# **AJAX Soils Review**

## **Kent Watson**

### **April 10, 2016**

This document reviews the following Appendices in the Ajax Environmental Impact Study. I have focused on the soils, geology and landform portions of the report. I have used screen captures for maps, tables and text sections that are too large to re-type. The documents were copy protected and text could not be copied and pasted.

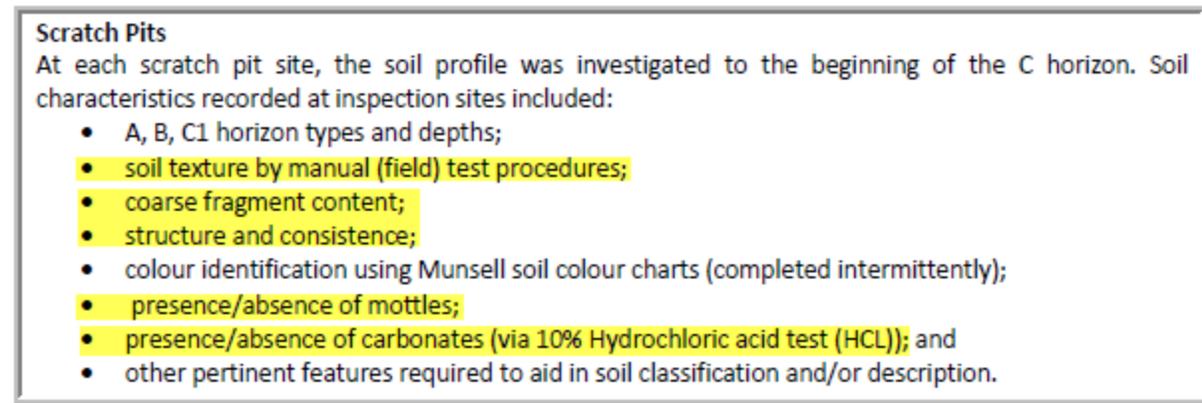
**Figure 4** This may be referring to the pits that were sampled and discussed later. 32 pits were analyzed for texture and coarse fragments and are discussed later. Hand texturing was not done. Structure and consistence were not done nor were mottles identified. Carbonates do not appear to have been done in the field. The scratch pit soils were never classified or described according to the Canadian System of Soil Classification (CSSC) (1998).

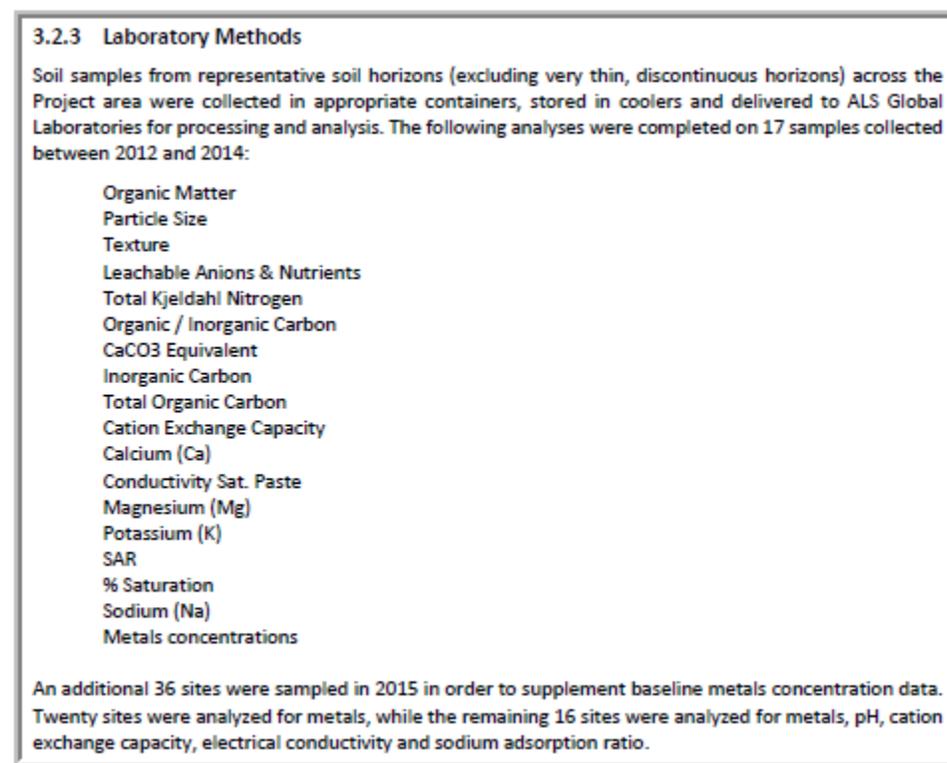
**Figure 6** This was done and is the only useful information regarding soils I have found in the sections I have reviewed. My findings using the data provided are discussed later.

Figure 1. Soil associations within the Ajax Project site

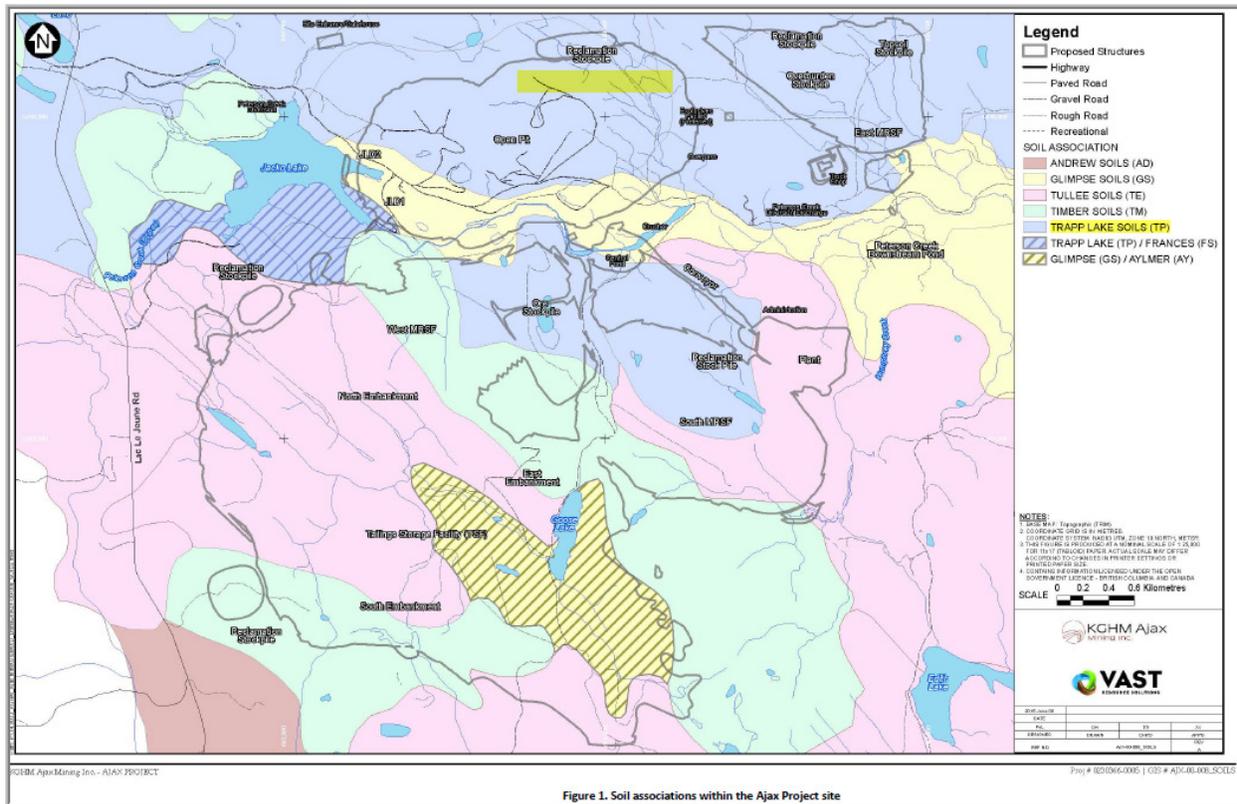
**Figure 10** The boundaries are identical to the Soils of Ashcroft Map sheet. They have merged soil associations of the same name and lost the soil association component the landform classification component and slope class component. This map has been generalized and detail has been lost. The Trapp Lake Soils (TP) highlighted in yellow in the Legend and blue at the top of the map containing the yellow highlight is an amalgamation of three TP units with different soil associations, landforms and slope class components. Why generalize the soils information when soils detail for this assessment should be at it highest level? The soils of Ashcroft Report is a reconnaissance level report and generalized to begin with as shown in **Figure 11**.

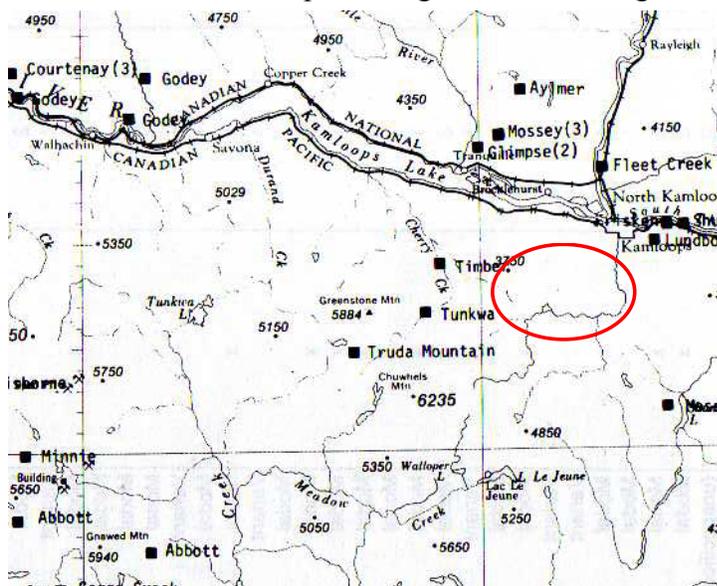
**Figure 11** The map scale is 1:100,000. The square boxes are soil sample sites. There are no soil pits in Ajax study area (red ellipse). The soil mapping was done using aerial photographs and extrapolation of soil information from sites located, often, many kilometers away.

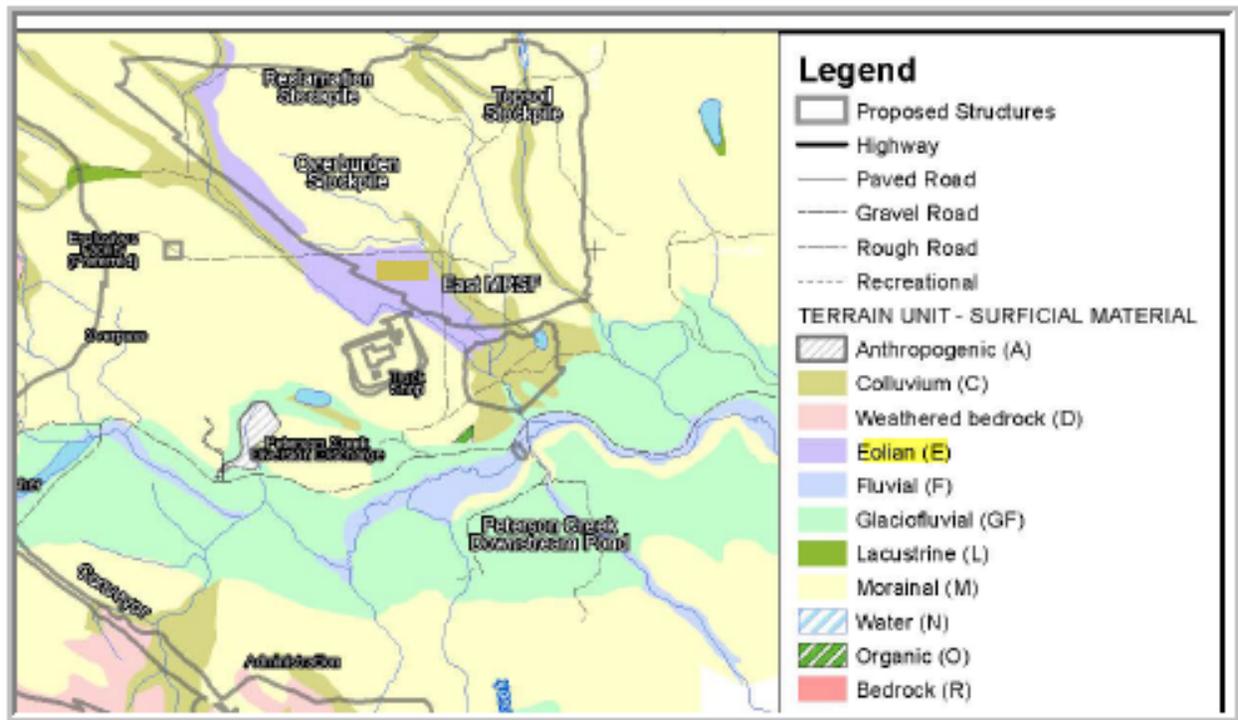
**Figure 12** This is a portion of Figure 2 from Appendix 3 - E. The Eolian (wind blown silt from the “large glacial lacustrine benches”) has the overburden stockpile sitting on top of it. Silt is highly mobile in water and is susceptible to erosion by water even at depth. Placing the overburden on this material is hazardous since the water that flows in existing streams and ground water may be forced to move in different directions that could lead to sub surface erosion and collapse of the stockpile.

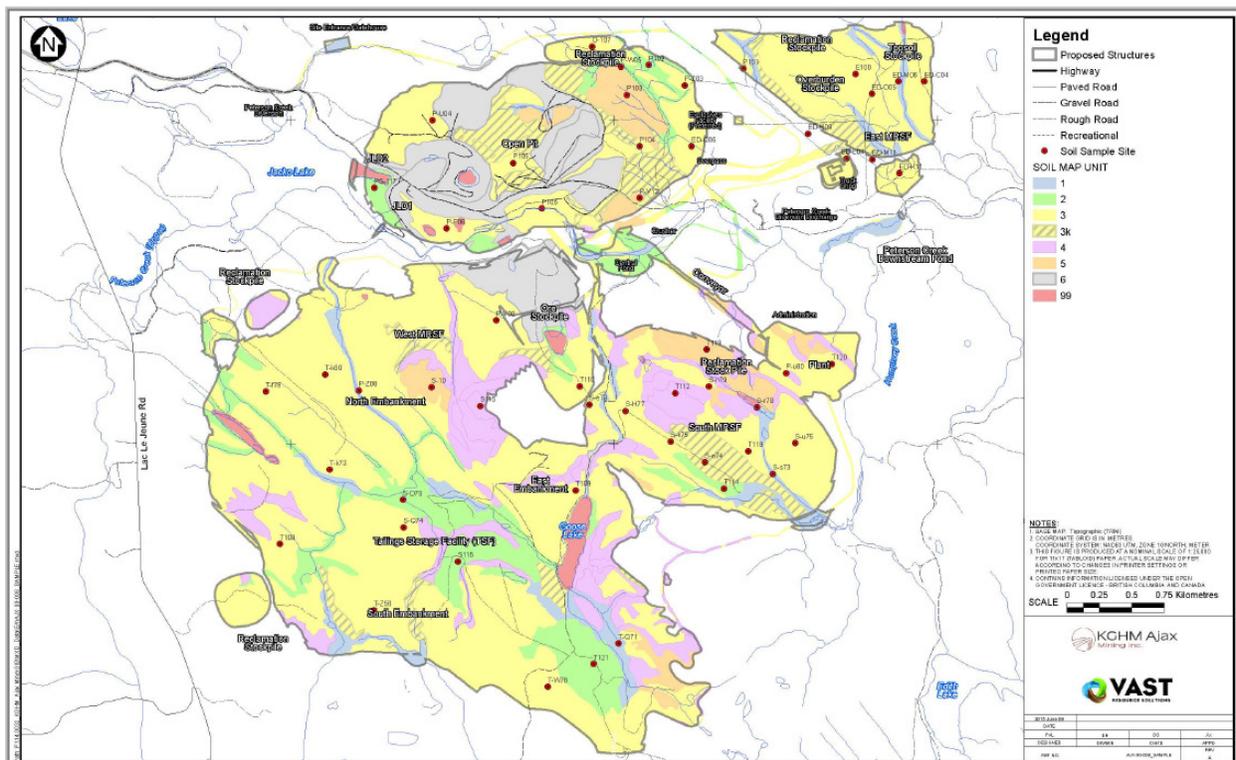
**Figure 15** The red sample sites used to determine depth, lab textures and elemental composition.

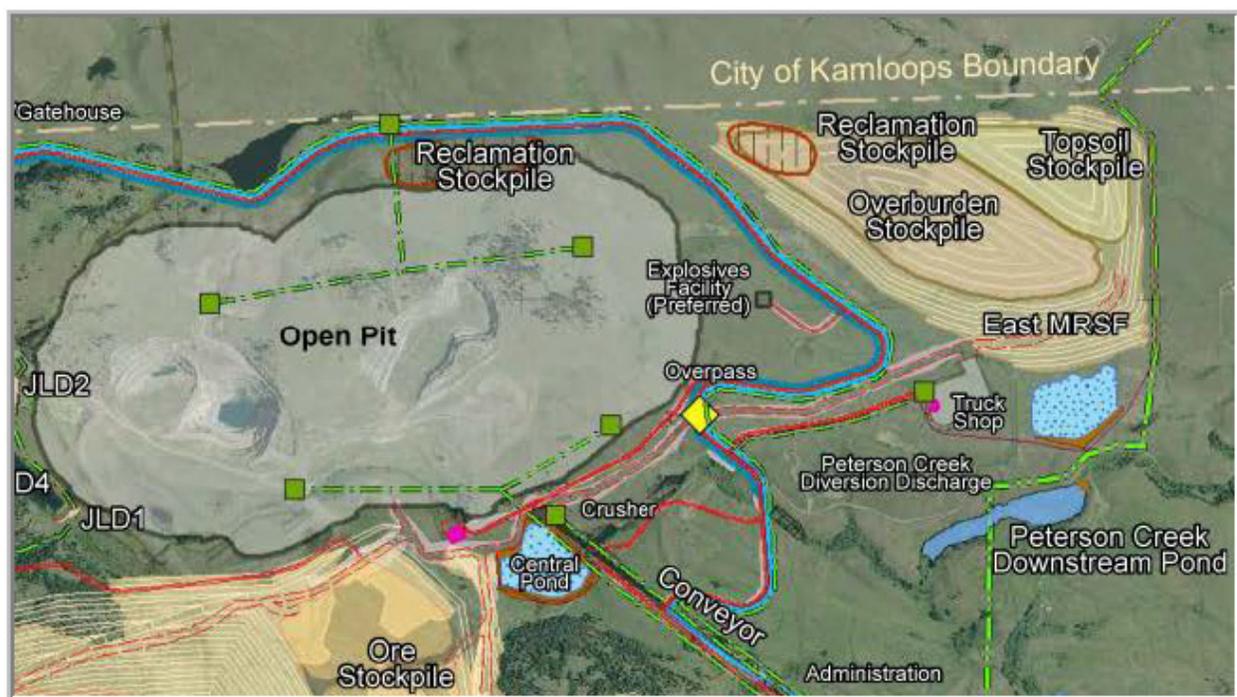
**Figure 17** Reclamation, topsoil and overburden stock piles containing  $4,393,527 \text{ m}^3$  of silt or  $5,623,714 \text{ tons}$  of silt are located on the city boundary waiting to be blown into Aberdeen and the city.

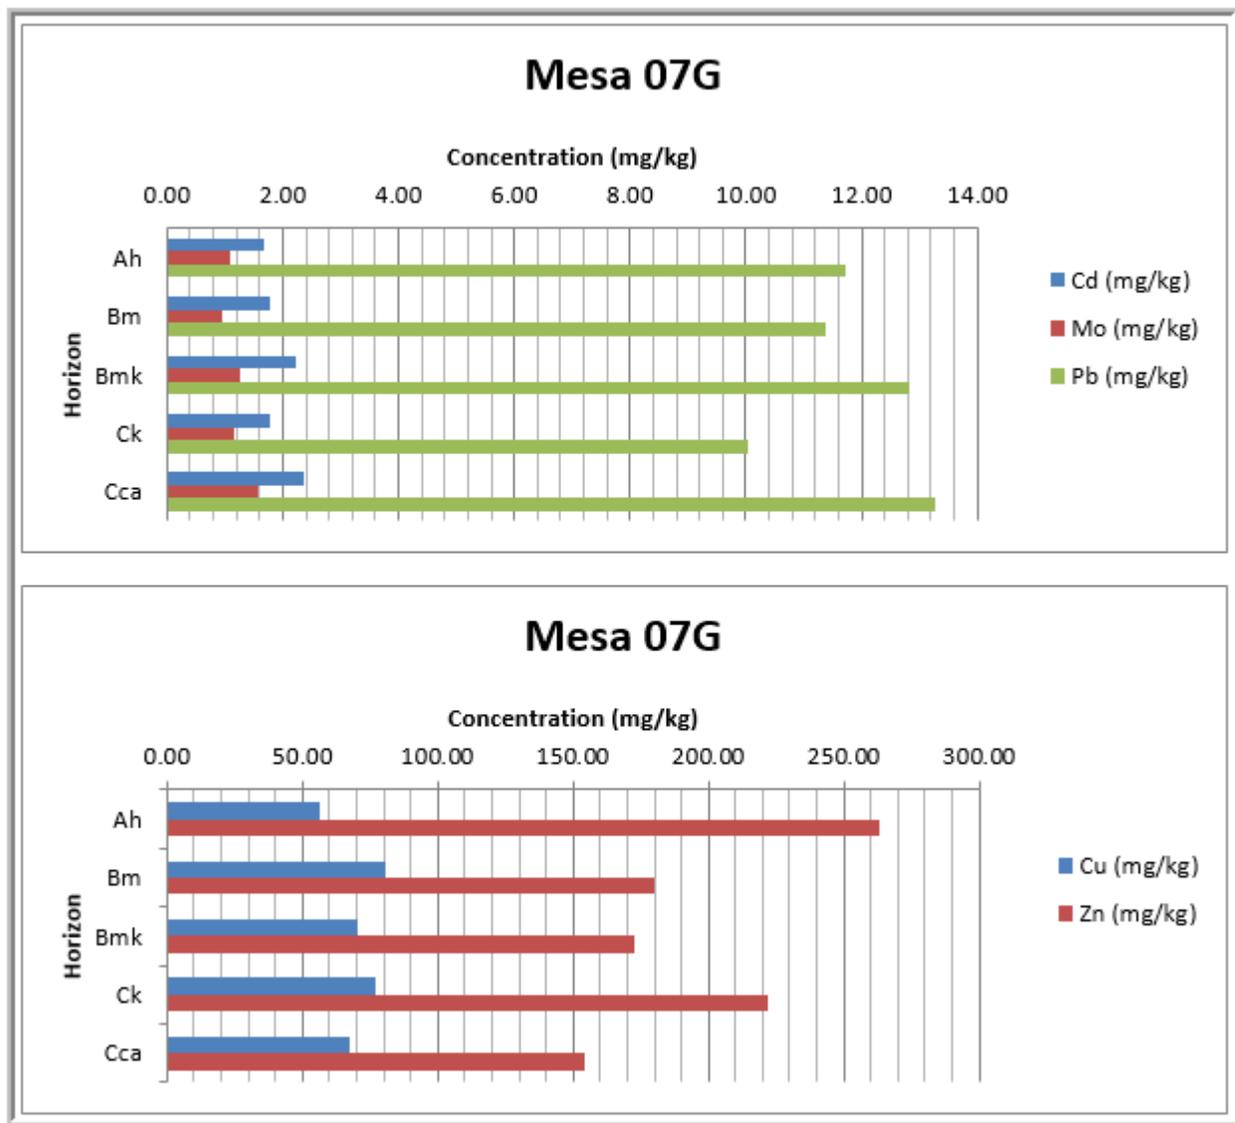
**Figure 22** This is one set of graphs for two sites. The sites were located around Kamloops. Lindsay's results showed that copper was above both the Agriculture and industrial limits (**Table 1**). Cadmium and zinc were above the Agriculture limits while the data from Appendix 3 - E showed values below the agriculture limits. The question is why the discrepancy. At TRU we do not have the equipment to run the other elements. However, a source of funding may be available to complete the work.

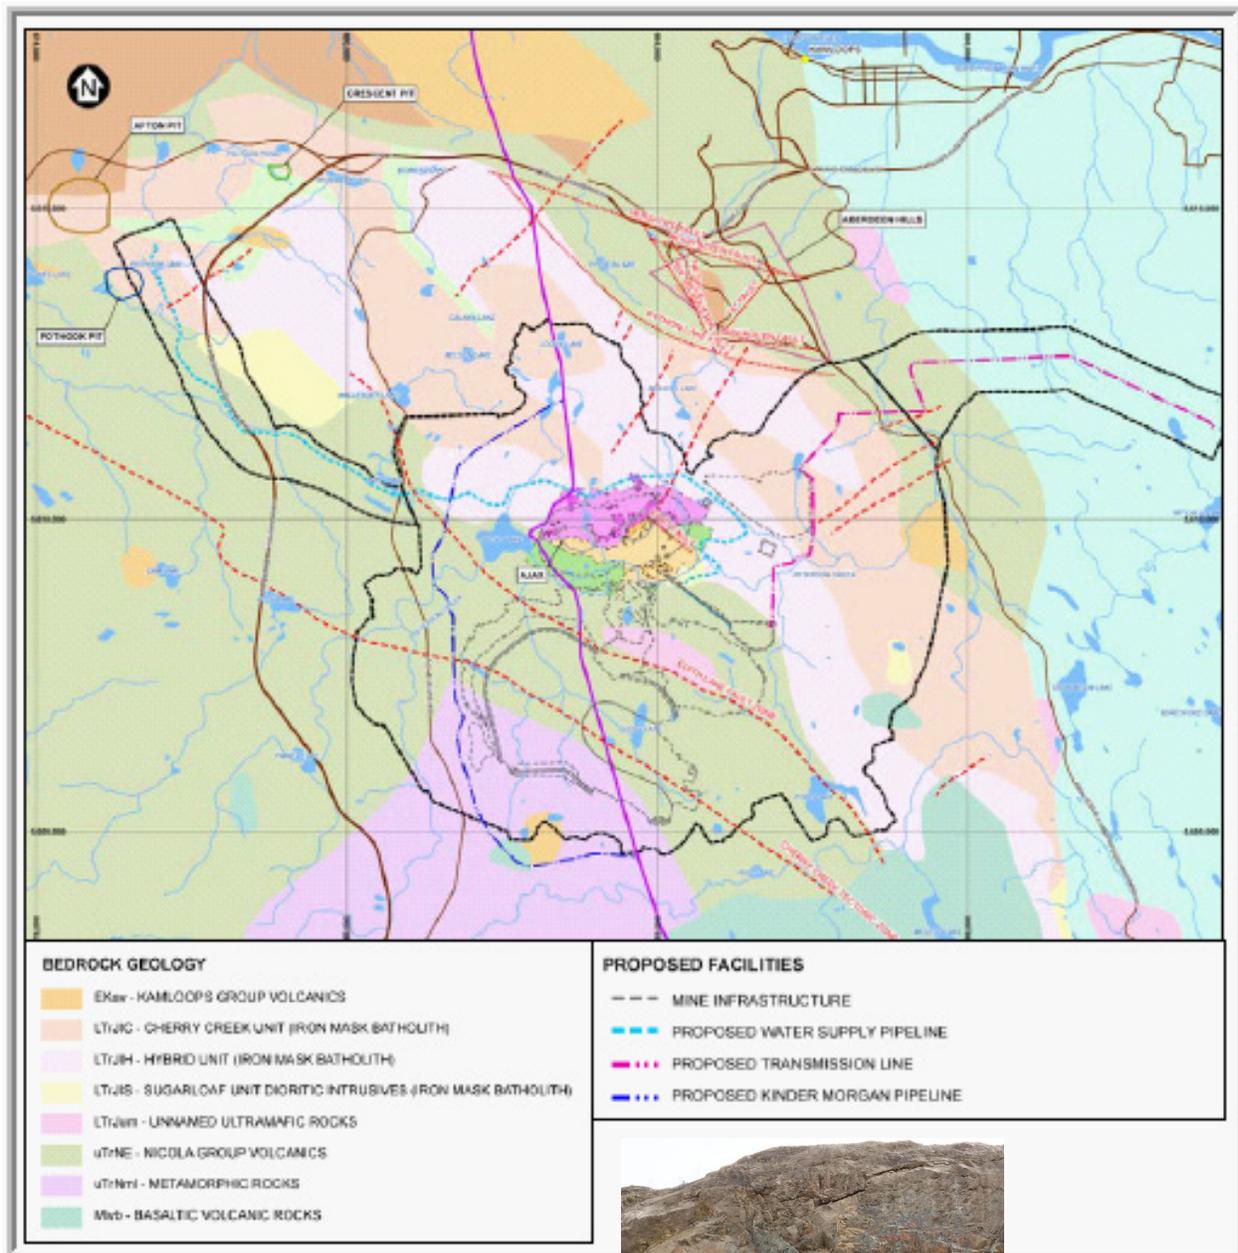
**Figure 23** The Kamloops Group and the picrite unit of the Nicola Group are historically prone to landslides. The Kamloops Group occurs in the Aberdeen Hills subdivision. The slides are bounded by a network of faults. There are a number of faults that connect the mine site with the fault system in Aberdeen. **Figure 23** shows a fault above Costco and shows that water moves along fault zones.

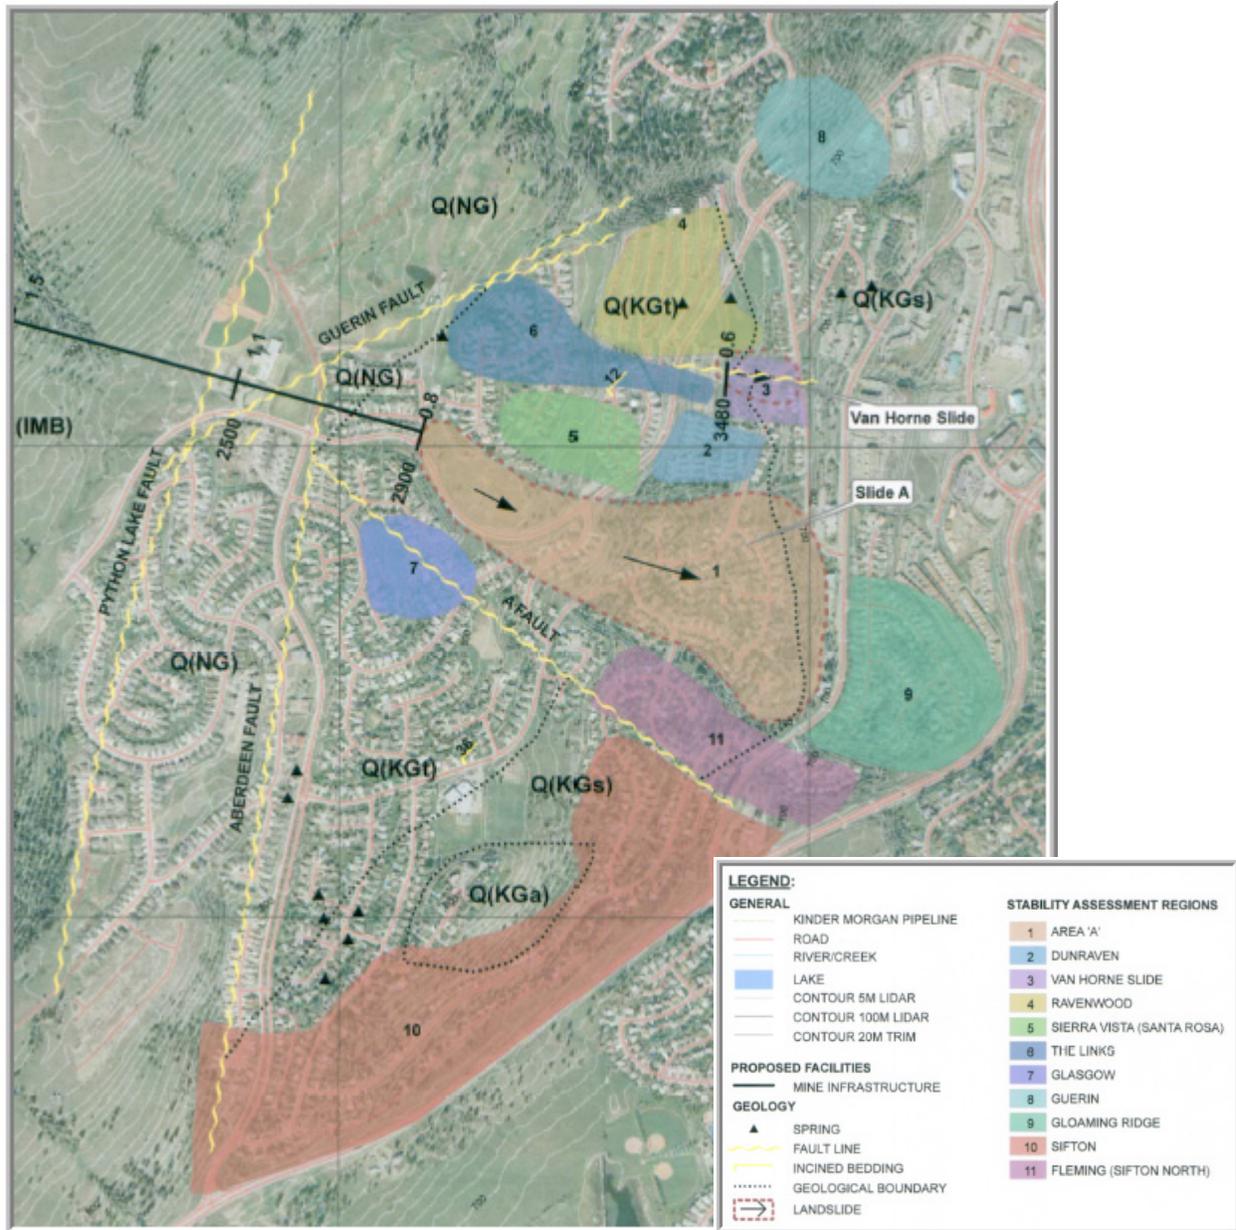
**Figure 26** The fault and slide map showing the Aberdeen slides. There are 6 slides. Five developed in the past 30 years. Initially there were 11 wells established to drain the water. Now there are now 30. Appendix 6.2-D discusses the effects of blasting and pore water pressure. There does not appear to be a discussion between the relationship to faults and water? There are also natural springs in the area.
